# SERVICE INFORMATION LETTER

SIL # 171017-23072-1400WE

**SUBJECT:** The outer diameter of the heat shrink tubing on the Speed Pickup is too large and causes difficulty during installation into the NHA.

**Figure 1**, Side-by-Side Image of Speed Pickup Showing Heat Shrink Tubing

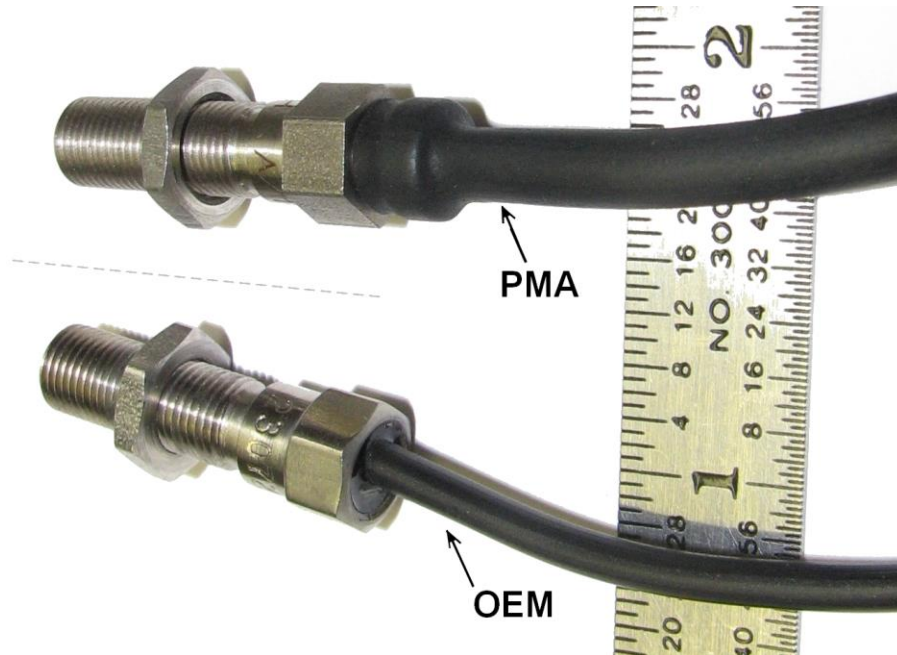
Some customers have complained that the OD size of the heat shrink tubing is causing difficulty installing the Wencor Speed Pickup. The OD size of the Wencor Speed Pickup is approximately 0.175", while the OD size of the OEM is only approximately 0.115". The Speed Pickup wires that are covered by heat shrink tubing must pass through a grommet when installed on the NHA DC Starter-Generator as shown in Figure 3. The larger size heat shrink is more difficult to pass through the grommet.

Any Wencor Speed Pickup Assemblies that are currently uninstalled that have been purchased prior to the date of this SIL may be returned to Wencor for replacement at the discretion of the end user.

However, any Wencor Speed Pickup Assemblies that are currently installed into the NHA, passed the required CMM testing for the NHA and are in service, may remain in service at the discretion of the end user with no risk to normal operation.
